February 28, 2017
BOARD OF COUNTY COMMISSIONERS
ORANGE COUNTY, FLORIDA
Y17-731-CC / ADDENDUM # 3
WITTENSTEIN COTTAGE ADA UPGRADES AND RENOVATIONS
Bid Opening Date: March 7, 2017

This addendum is hereby incorporated into the bid documents of the project referenced above. The following items are clarifications, corrections, additions, deletions and/or revisions to and shall take precedence over the original documents. Underlining indicates additions, deletions are indicated by ~~strike through~~.

A01.01

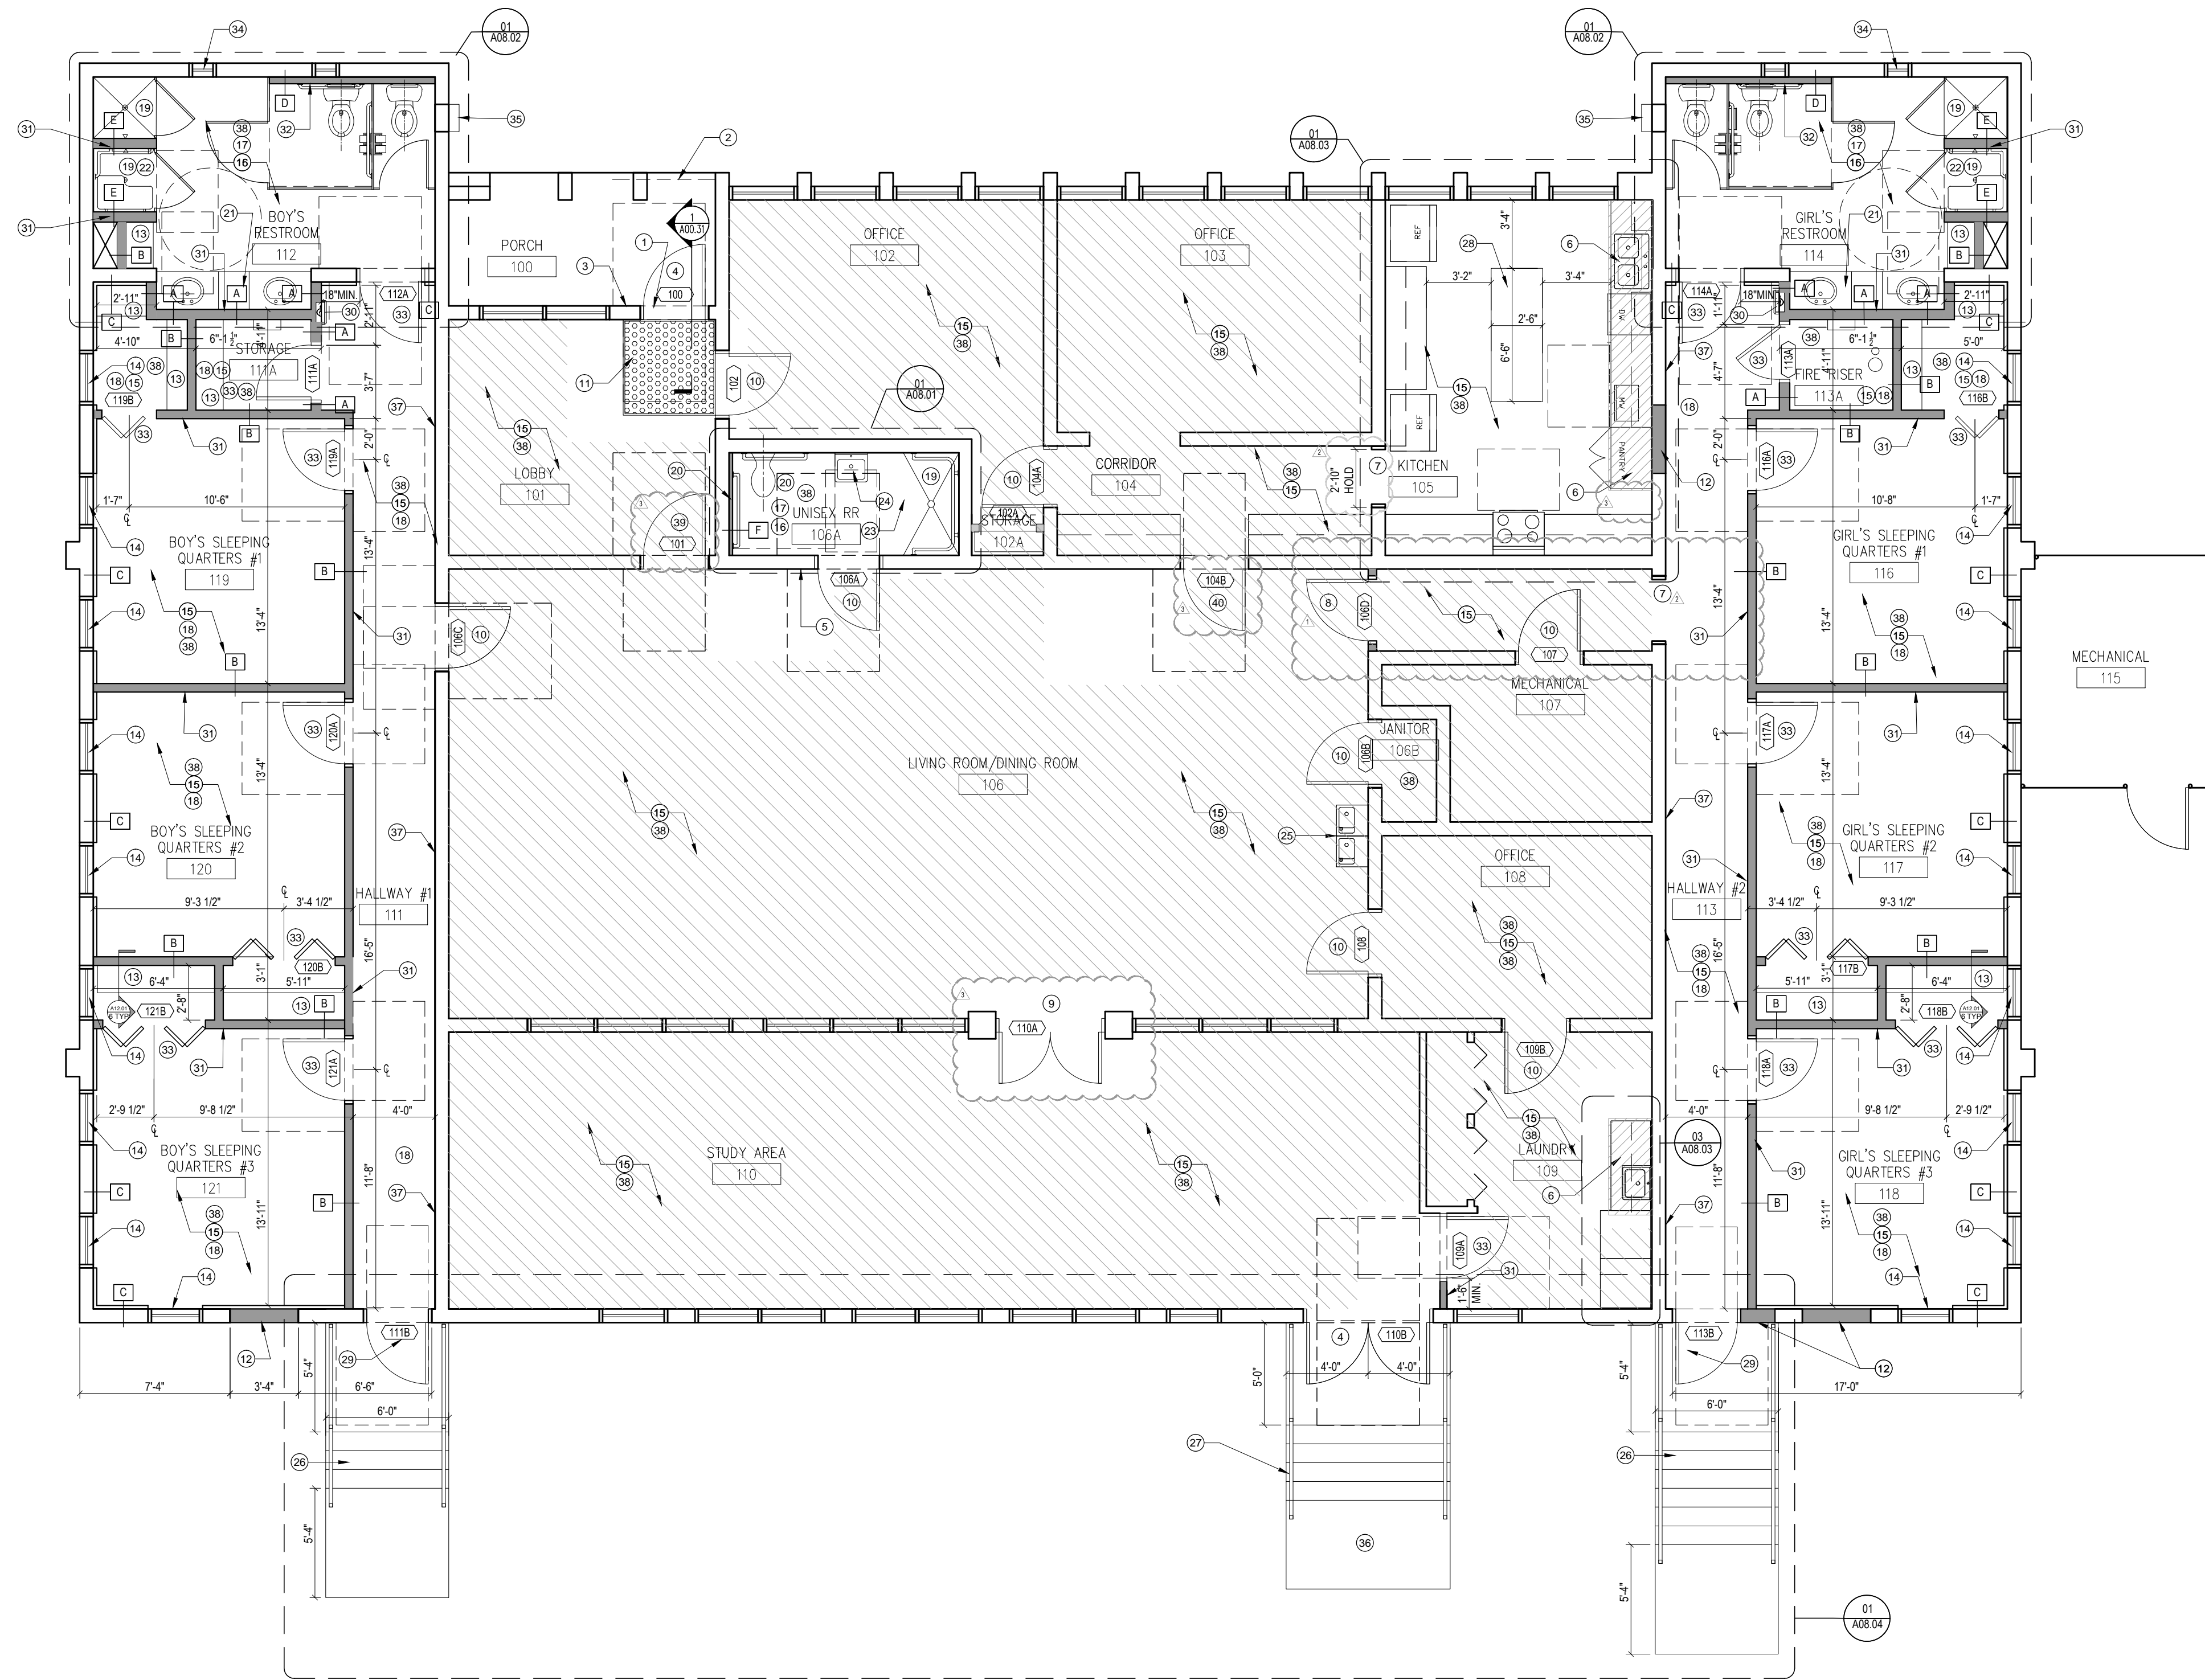
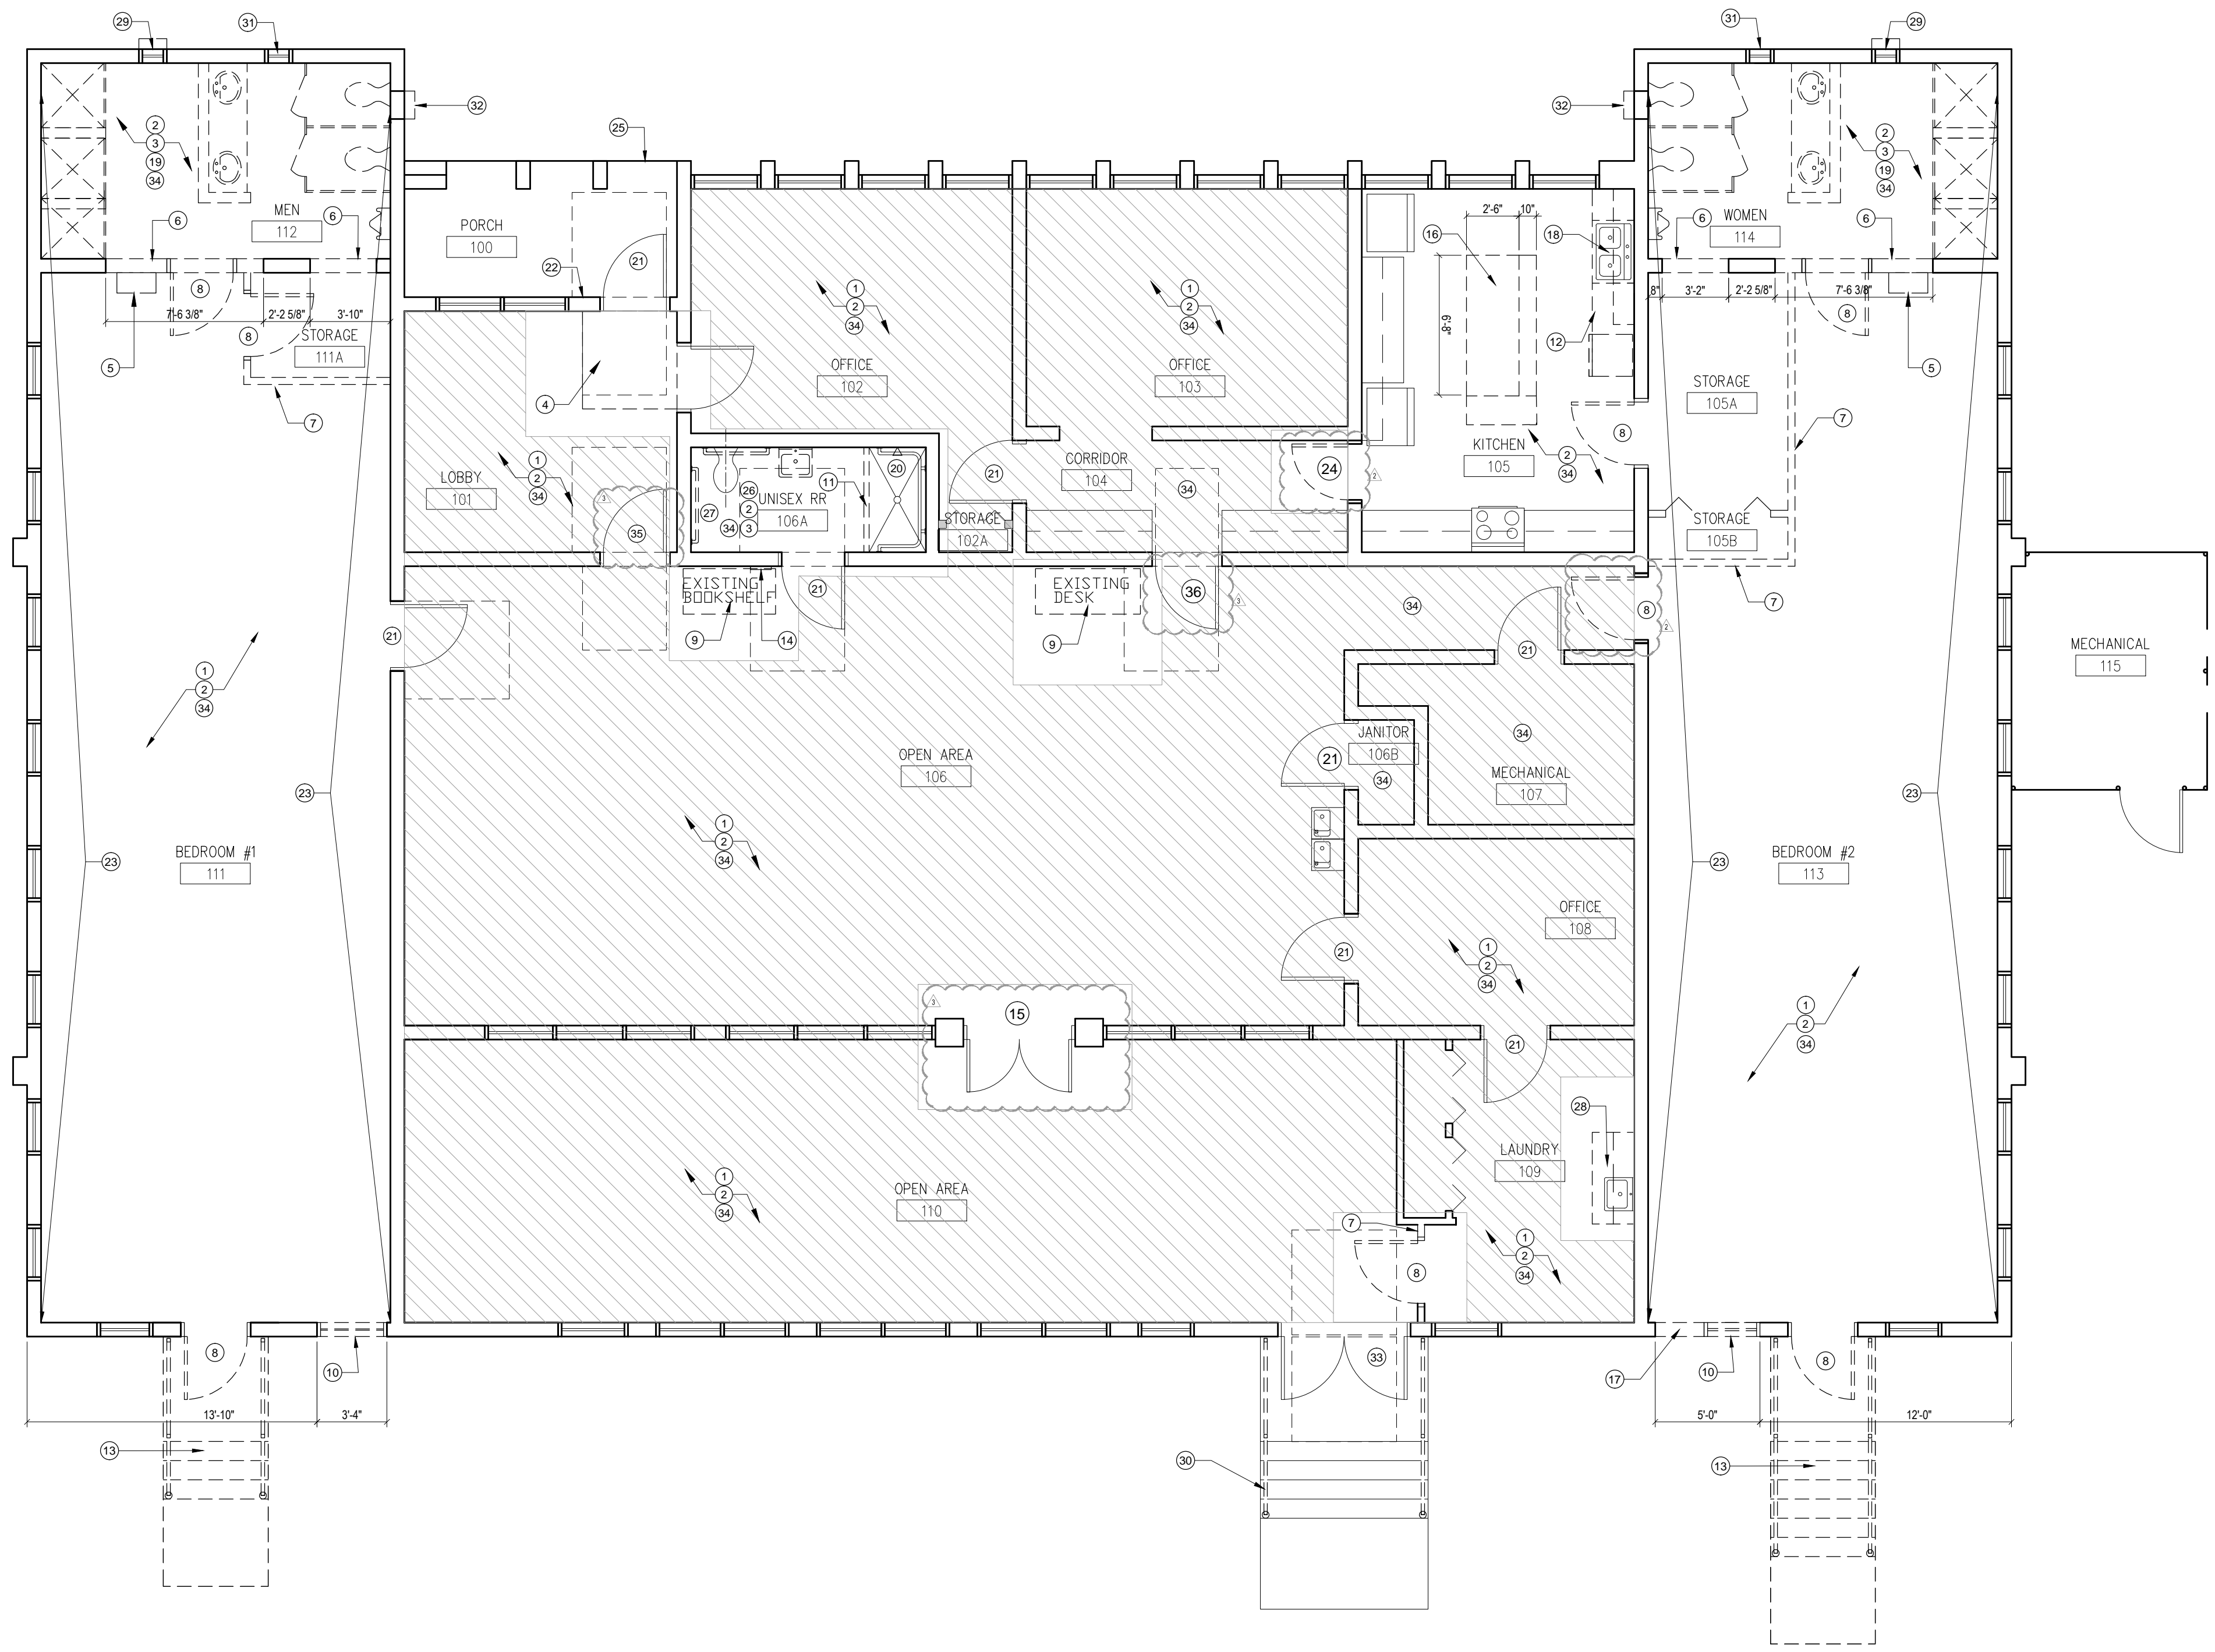
5. Question: Note 7 on Construction plan A02.01 calls for a cased entrance to the kitchen. Specs do not detail shape or style of casing.

Answer: Existing trim to remain. Remove door and hinges, patch and repair frame where hinges were removed. Note: changes have been made to sheet A01.01 and A02.01, see attachment.

File Name
X:\dwgs\15253 OC Wittenstein House ADA\CAD\SHEETS\A04.01A DEMO REFLECTED CEILING PLAN.dwg

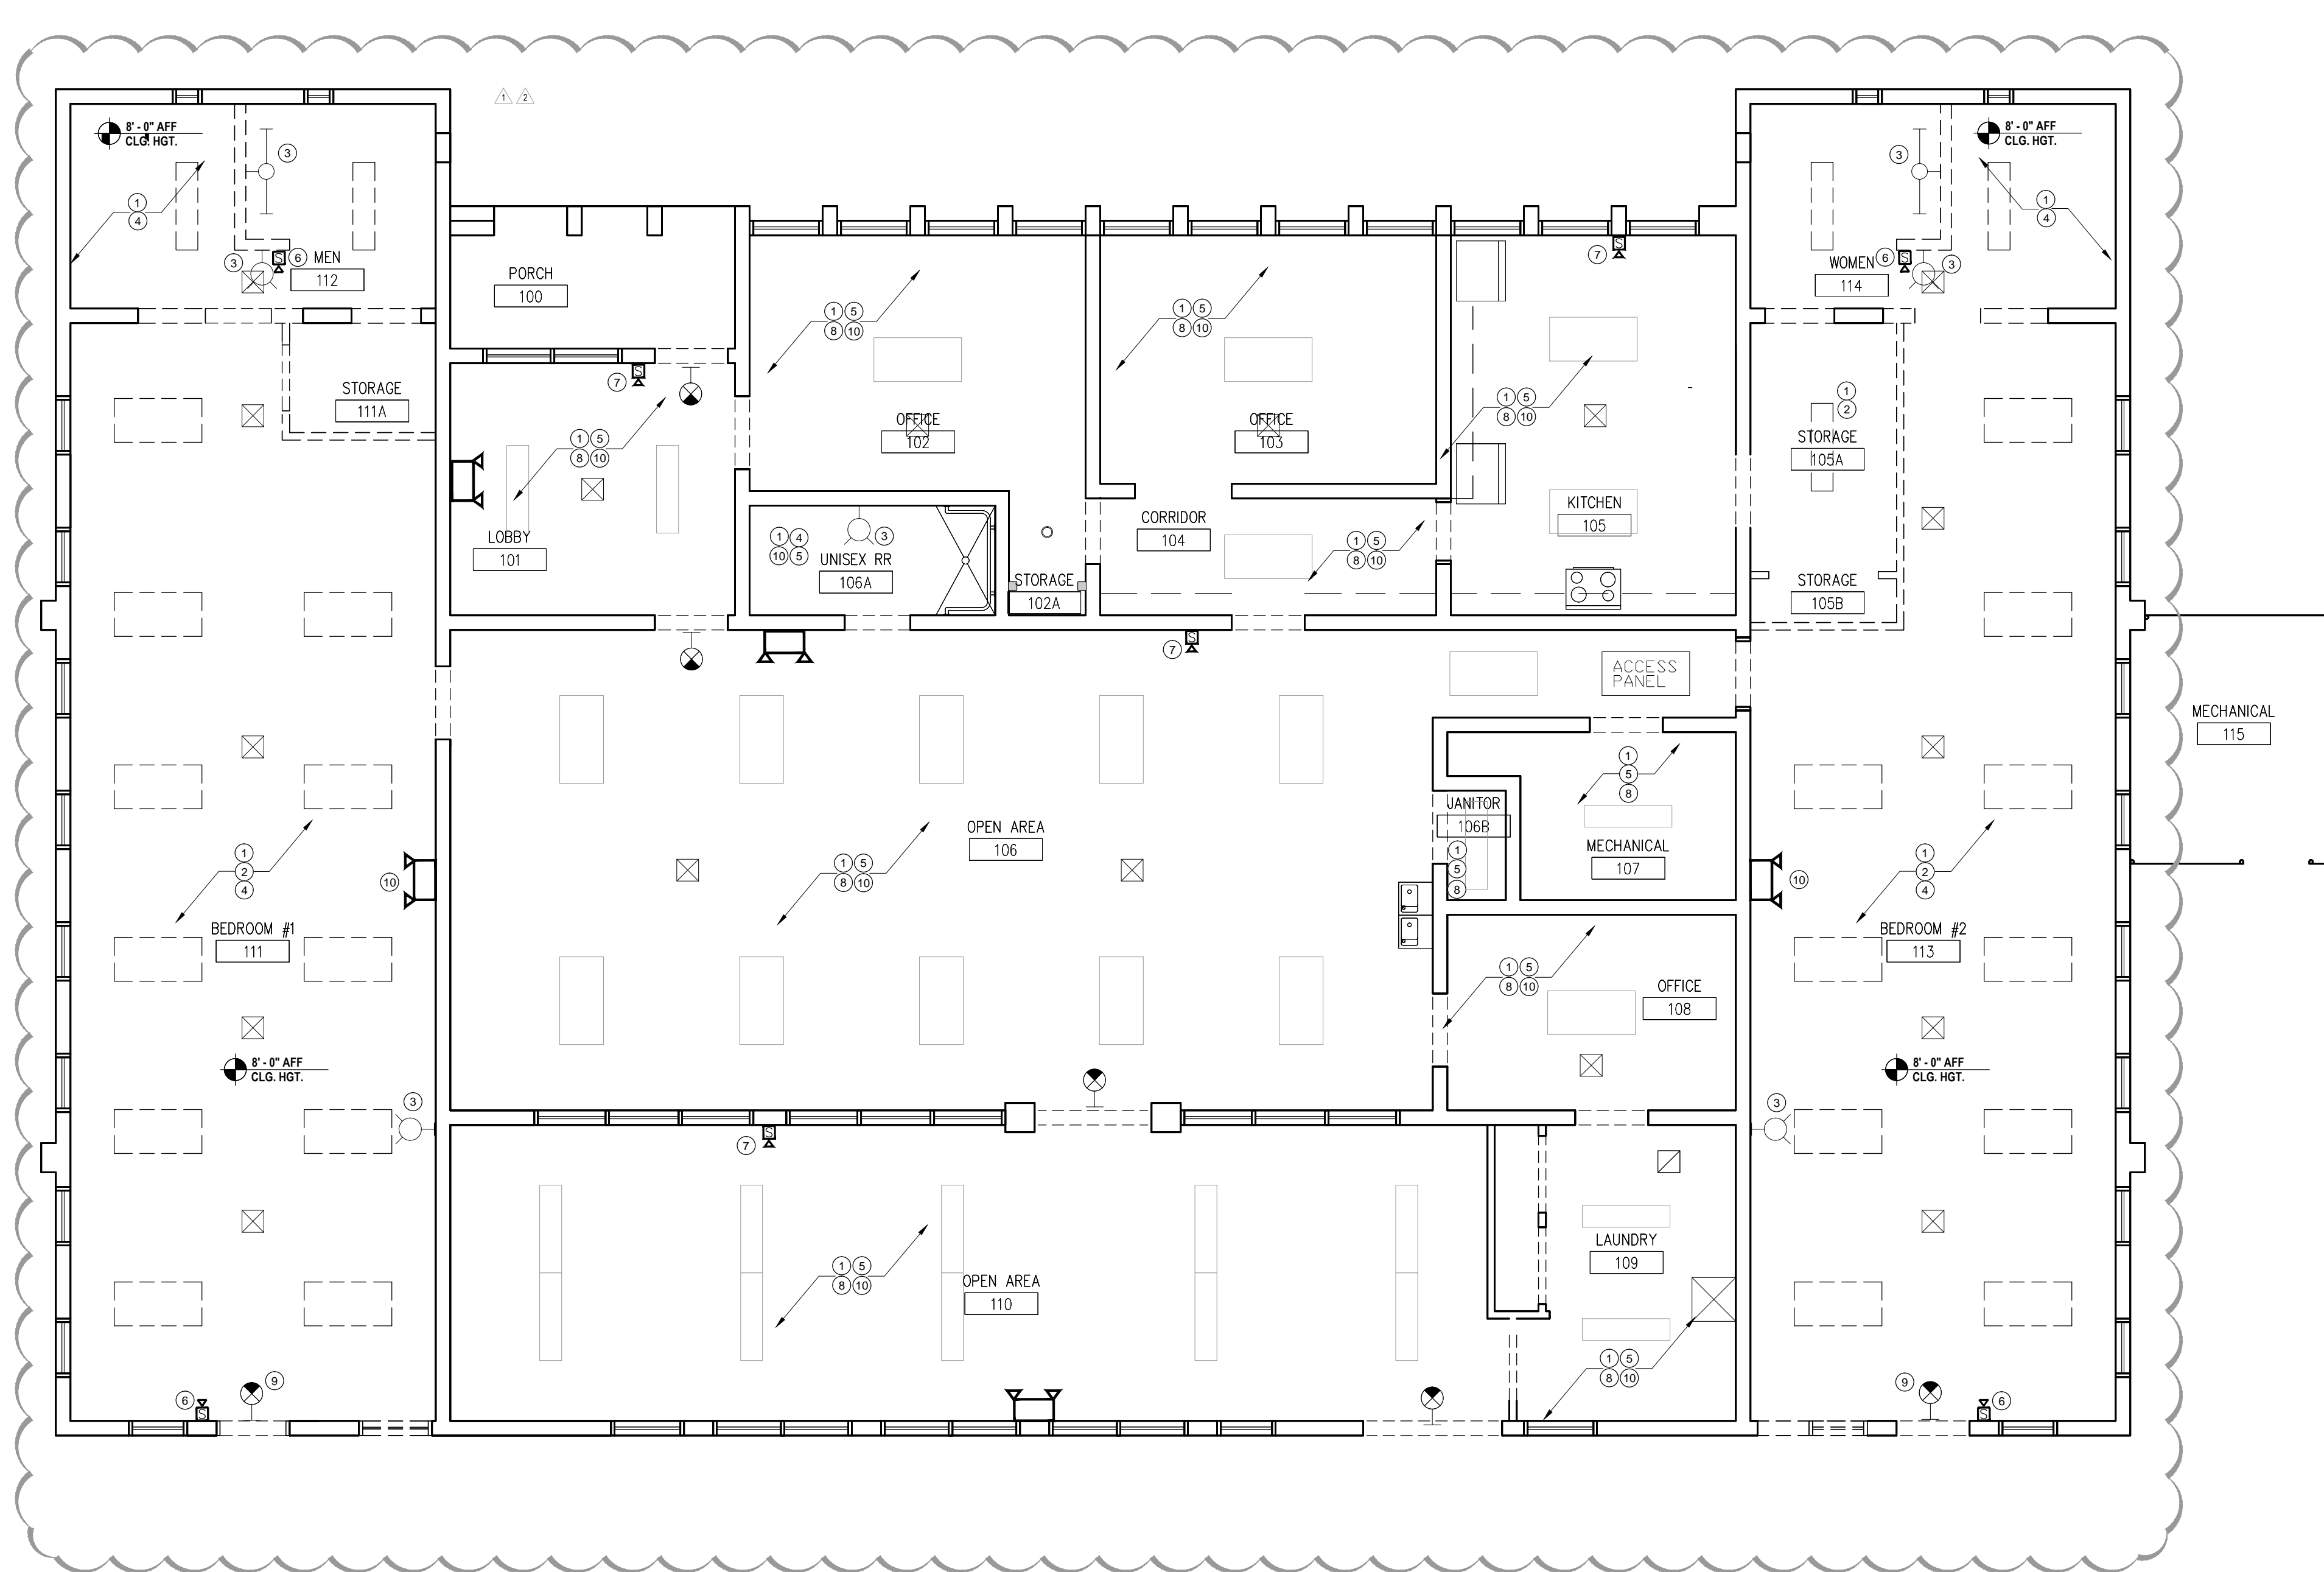
7. Question: On A04.01, a key note 11 is referenced on the drawing in several places. Should this be key note 10?

Answer: Corrections have been made sheet A04.01A, see attachment.
